AIR NAVIGATION COMMISSION

**FINAL REVIEW OF PROPOSED AMENDMENTS TO
ANNEX 14, VOLUME I ARISING FROM THE AP/2 MEETING AND CONSEQUENTIAL
AMENDMENTS TO ANNEX 15 AND THE PANS-ATM (DOC 4444)
(Item No. 18807)**

(Presented by the Director of the Air Navigation Bureau)

Figure 5-24. Simple touchdown zone lighting

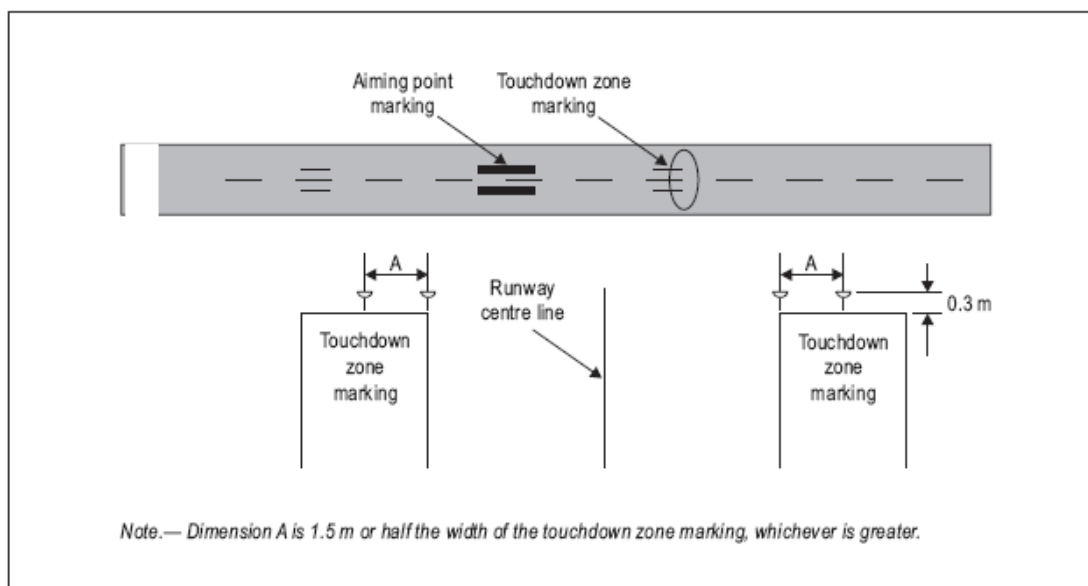
Add "Figure 5-24 Simple touchdown zone lights" (and re-number all subsequent Chapter 5 figures and text references to those figures) as follows:

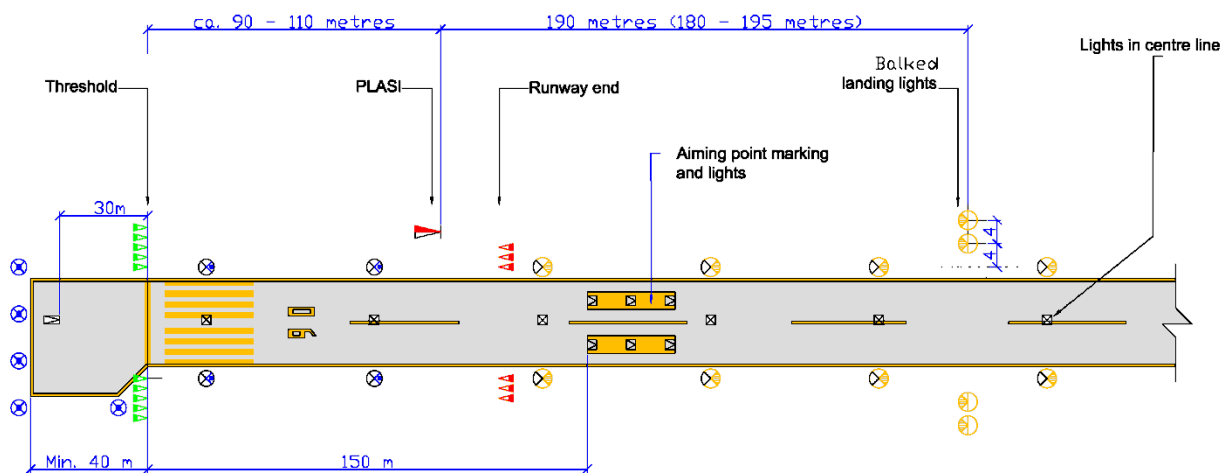
Amend paragraph 5.3.13.7.2 to read as follows:

5.3.13.7.2 Simple touchdown zone lights shall be a pair of lights located on each side of the runway centre line 0.3 metres beyond the upwind edge of the final touchdown zone marking. The lateral spacing between the inner lights of the two pairs of lights shall be equal to the lateral spacing selected for the touchdown zone marking. The spacing between the lights of the same pair shall not be more than 1.5 m or half the width of the touchdown zone marking, whichever is greater. (see Figure 5-24)

Refer the study of the upgrading of paragraph 5.3.13.7.1 to a Standard to the AP.

Figure 5-28 [modified]. Runway guard lights

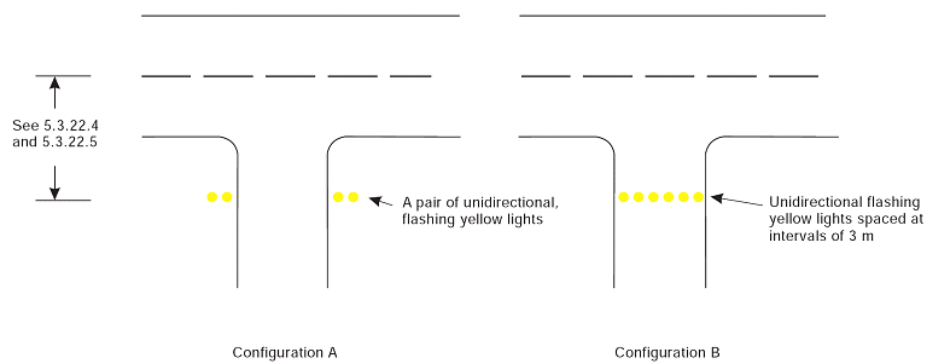
The present Figure 5-28 has only 5 lights for Configuration B whilst the requirement in 5.3.22.17 is that adjacent lights shall be alternately illuminated. As such, there must always be an even number of lights regardless of the width of the taxiway.

Fig. 5.5 Taxiway side strip markers

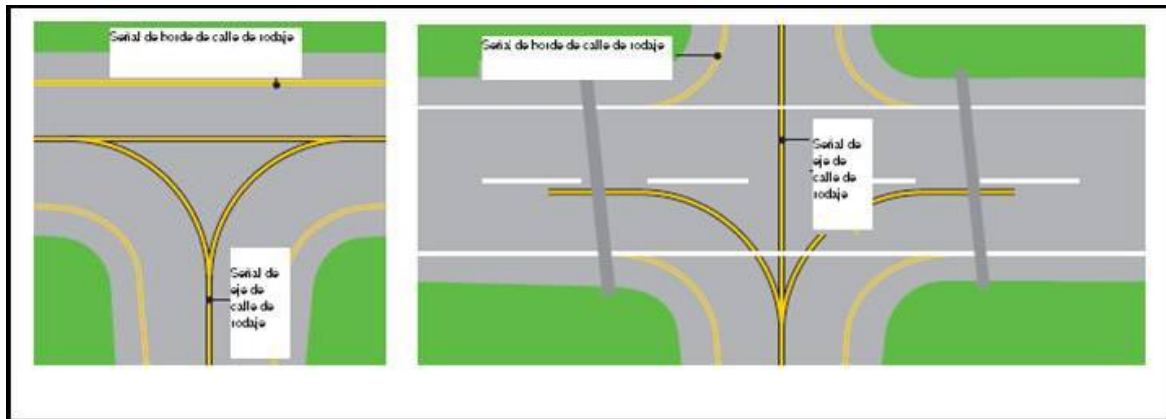
5.2.9.1 Recommendation. Taxiway side strip markers shall be positioned to mark out the border between the edge of the usable taxiway and the edge of the pavement, with the outer edge of the marker strip being the usable edge of the pavement, See figure 5.5.

Fig. 5-6 Transversal strip marker

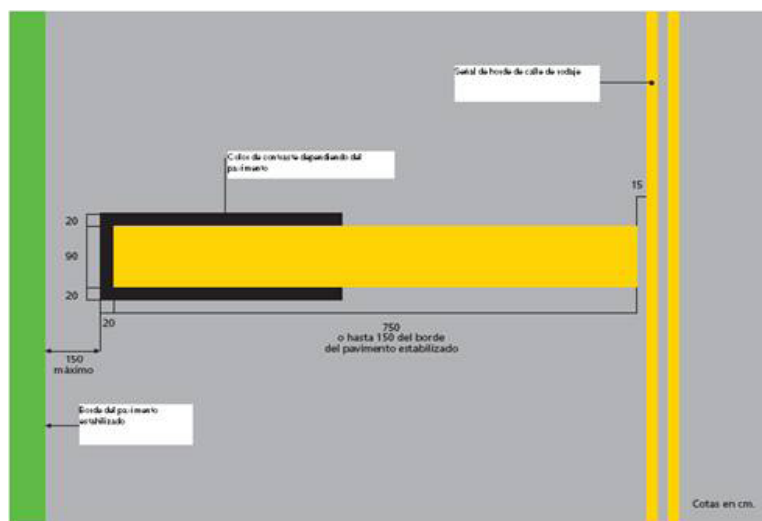
5.2.9.5 Where the edges of the taxiways, the runway turning platforms, the holding areas, the platforms, and other non-resistant surfaces cannot easily be distinguished from the surfaces suitable for supporting loads, the use of which could damage the aircraft, the limit between the surface and the surfaces suitable for supporting loads should be indicated by a taxiway side strip marker with the provision of additional side strips in accordance with 5.2.9.8. The characteristics of the taxiway side strip markers will comply with Fig. 5.6 and 5.7

Fig. 5.8 Non-continuous taxiway side strip markers

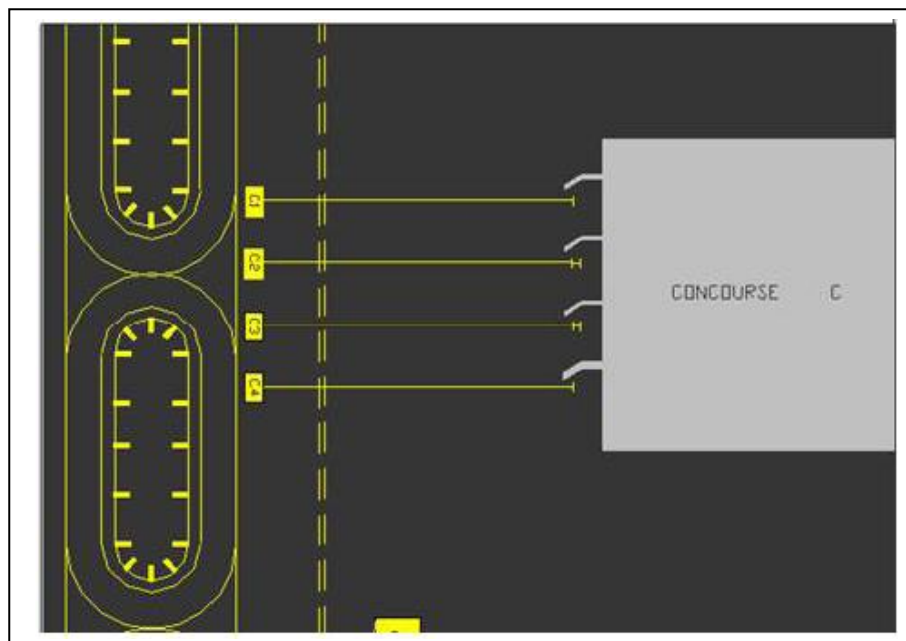
5.2.9.4 The markers on the edge of the taxiway in accordance with 5.2.9.3 will consist of a double continuous line, 15 cm wide, with a 15 cm separation, in the same color as the taxiway central markers, and the lines must be 4.5 m long with a 7.5 m separation. These markers must not be used to outline islands with the exception of some very special conditions, See figure 5.8.
